MECKLENBURG COUNTY GROUNDWATER & WASTEWATER SERVICES
APPLICATION FOR A RESIDENTIAL SITE IMPROVEMENT PERMIT/ CONSTRUCTION AUTHORIZATION FOR AN ON-SITE WASTEWATER SYSTEM, NEW WELL INSTALLATION, OR REPAIR OF EXISTING WELL

SOIL/SITE EVALUATION for ON-SITE WASTEWATER SYSTEM

RE: OID Camden

REVISION

M.C.G.W.S.
File: 7387-B
Lot 3 Old Camden Est.

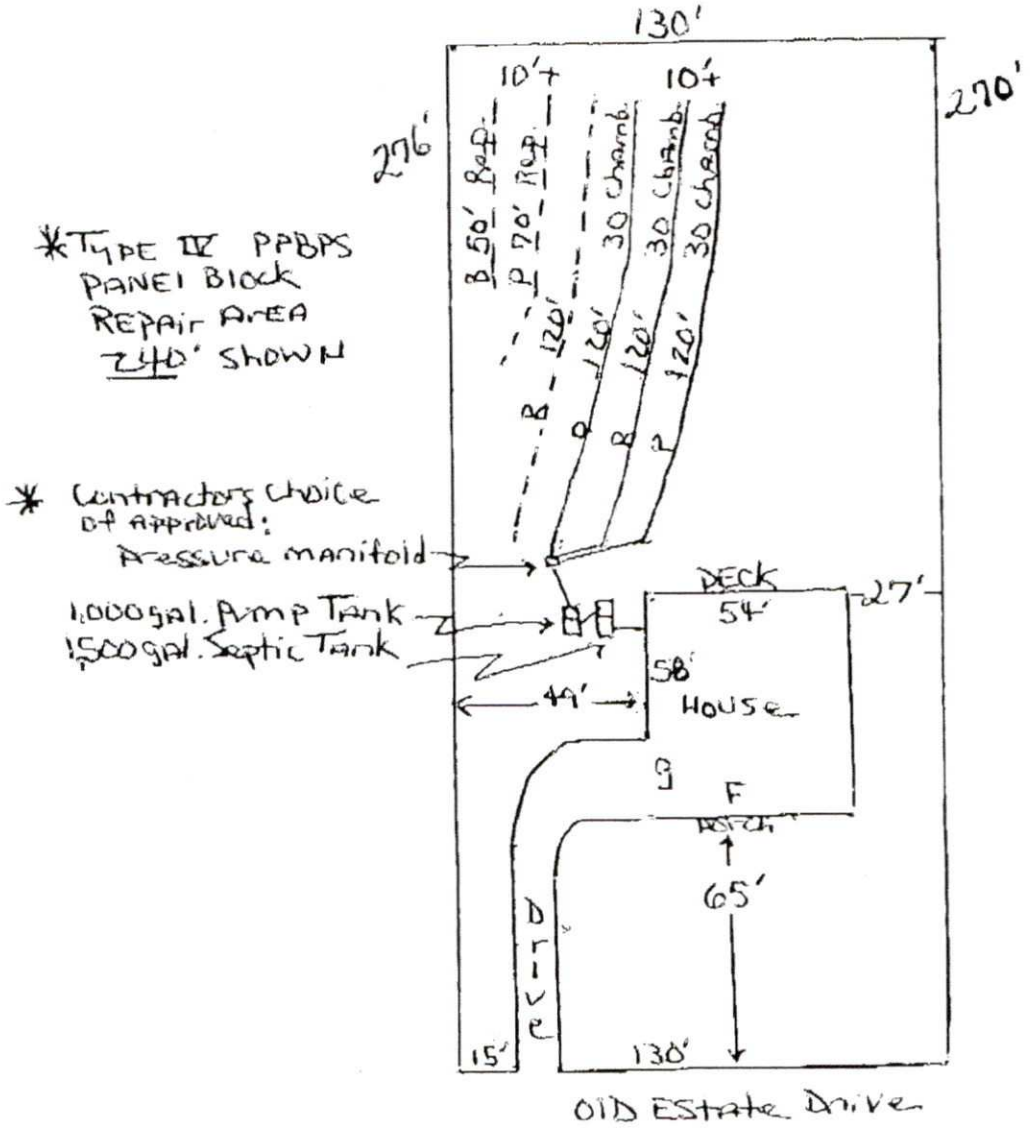
(3) ~~Bedrm~~. Pumped Chamber
panel Repair (See plan)

(3) Bedrm. 25% Reduction - Quick Four Septic Sys.
LTAR .25 1,500 gal. Septic Tank, 1,000 gal. Pump Tank,
Distribution - pressure manifold.
(3) 120' chamber Lines = 360'
(30) chambers per Line = 90 chambers REQ.

Revised 11/25/08
Tim Whittaker
704 636-4344
C/SC

File: 7389-B

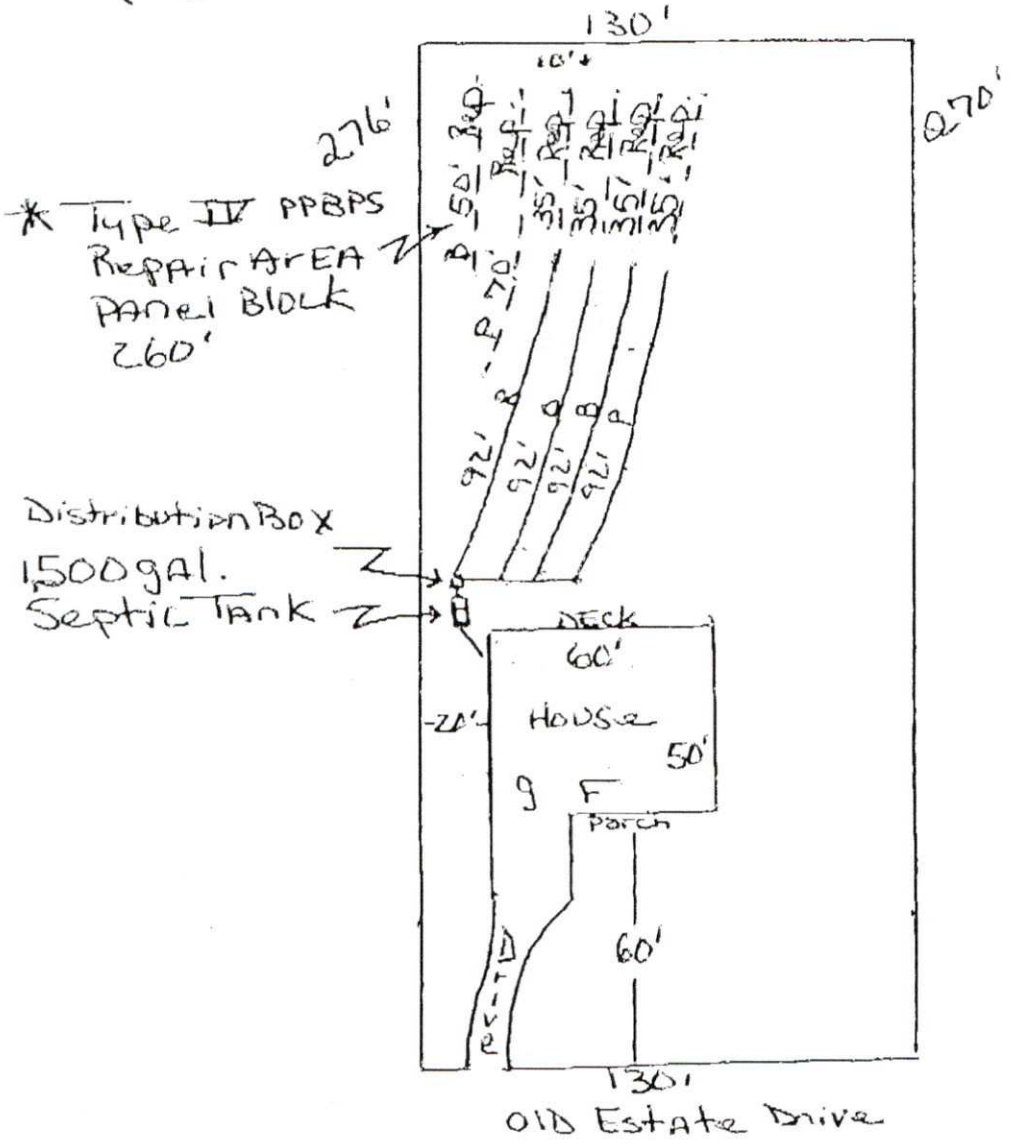
(3) Bedrm. Gravity Fed, 25% Reduction Septic Sys, LTAR .25 Quick Four Chamber. 1,500 GAL. Septic Tank, Distribution Box

(4) 92' Chamber Lines = 368'

(23) Chambers per Line = 92 Chambers Req.

* Bldr. Responsible for final grade to maintain gravity flow Septic Sys.
